Department of Energy  
Field Office, Albuquerque  
Los Alamos Area Office  
Los Alamos, New Mexico 87544

This letter provides information regarding changes to two interim status mixed waste Container Storage Areas (CSA) located at the Los Alamos National Laboratory (LANL). Both of the CSAs are managed by the Chemical Science and Technical Division (CST-7), and were originally identified in the January 1991 submittal of the LANL Hazardous Waste Permit Application, Part A for Mixed Waste. The changes do not involve an increase in design capacity.

Figure 8  
TA-21 - Site Location Map and Container Storage Areas

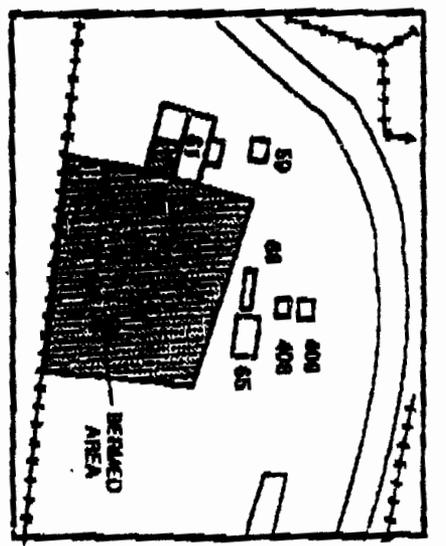
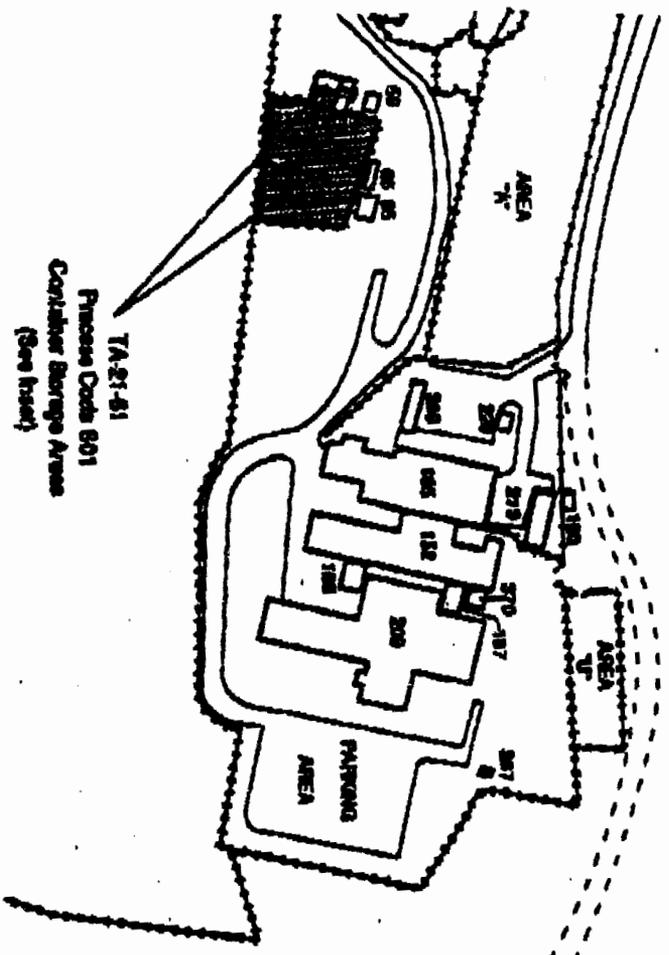
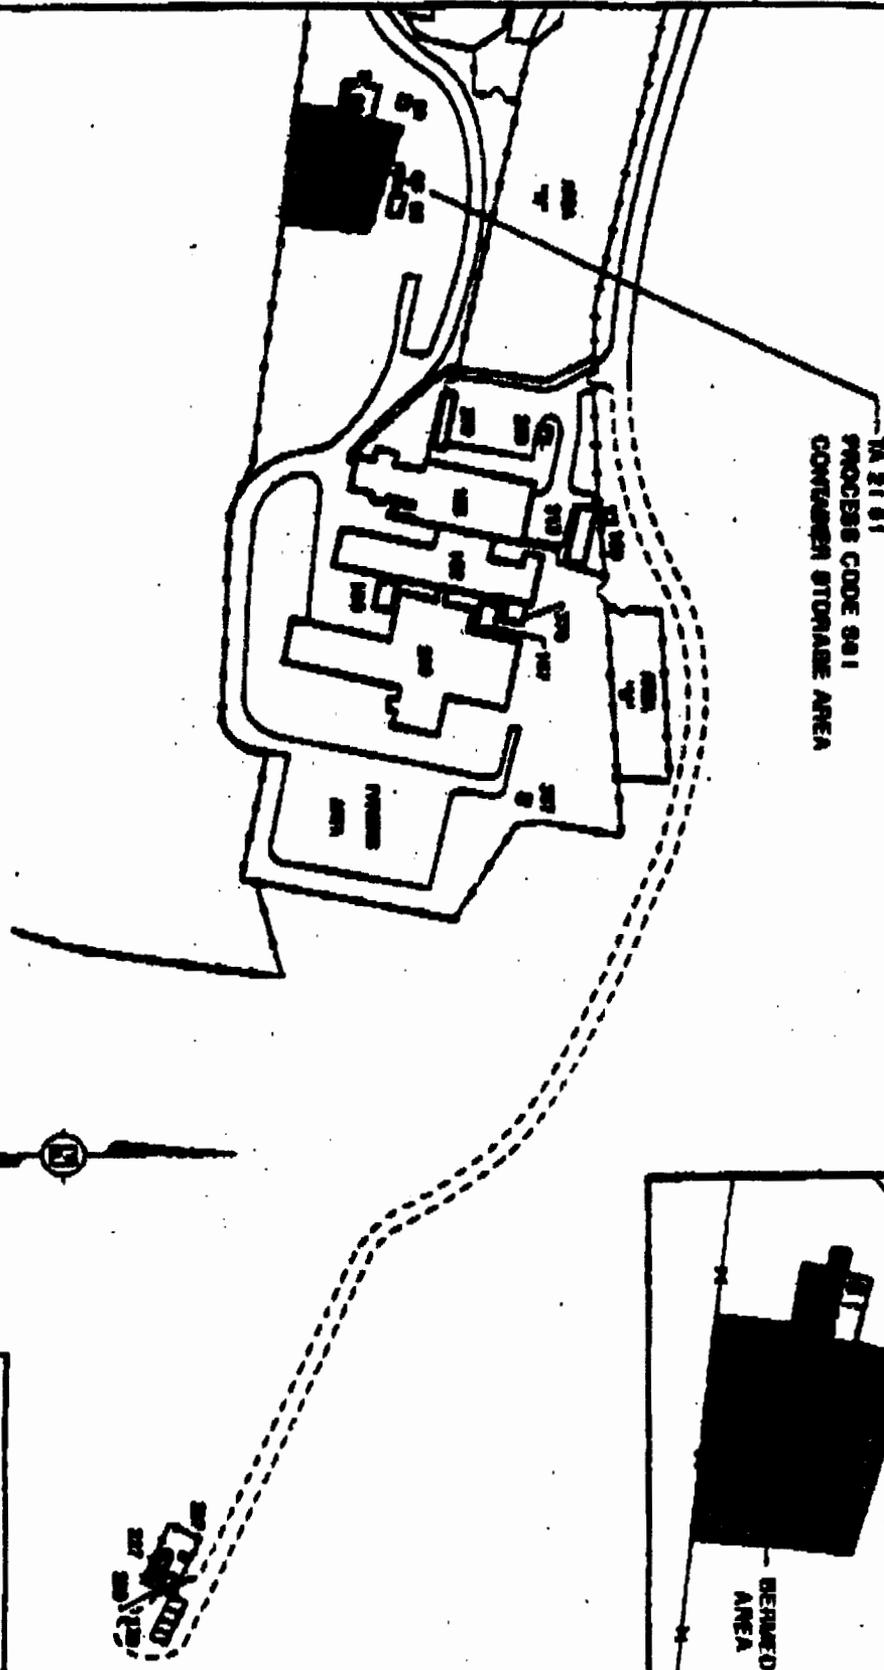
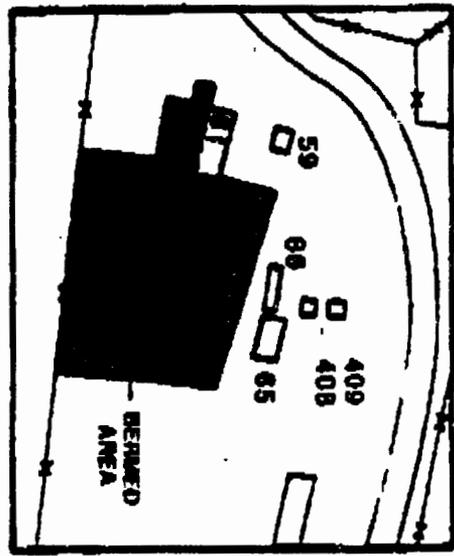
The CSA at TA-21-61 has been modified to reduce the area of allowable indoor storage. The indoor CSA originally identified for TA-21-61 has been reduced to allow less than 90-day storage of hazardous waste in the portion of the building no longer identified for mixed waste storage.

Figure 14  
 Waste Characterization, Reduction, and Repackaging Facility Container Storage Areas

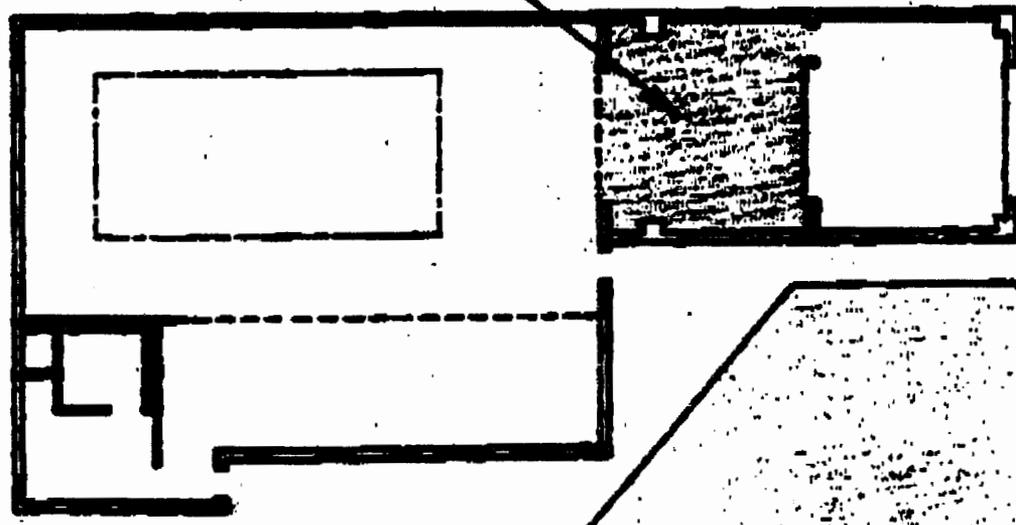
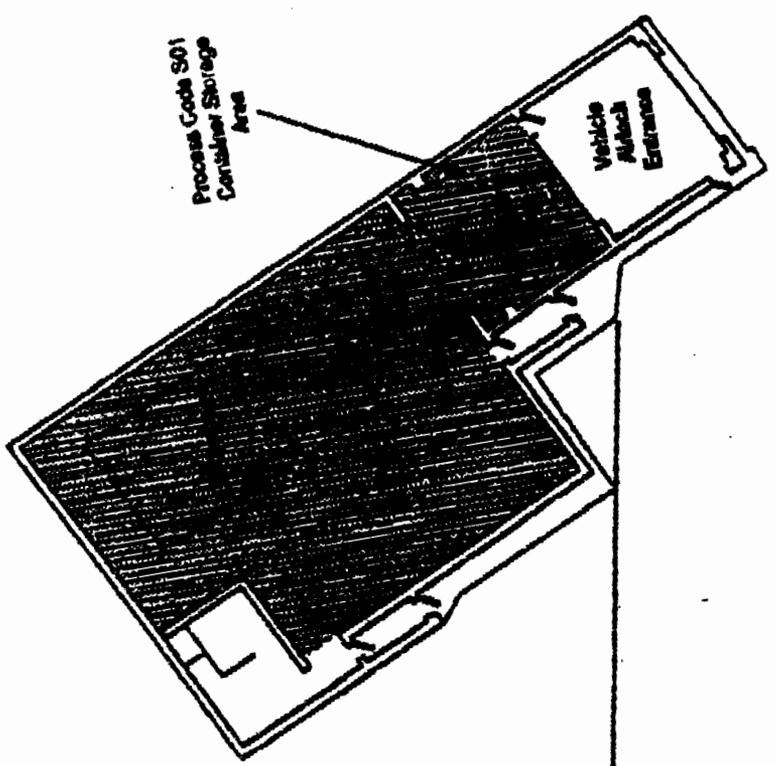
The CSA at the Waste Characterization, Reduction, and Repackaging Facility, Technical Area 50, Building 69 (TA-50-69) has been changed to reduce the area (and correct the shape) of allowable outdoor storage, and increase the area of allowable indoor storage. The area and shape of the outdoor storage area was incorrectly identified on the facility drawing in the original Part A submittal. The change to the outdoor CSA provides a more accurate representation of past, present, and anticipated mixed waste storage activities. The indoor container storage area has been increased to include all of the first floor of Building 69. This change allows facility personnel to store mixed waste inside the building while size reduction operations are conducted.
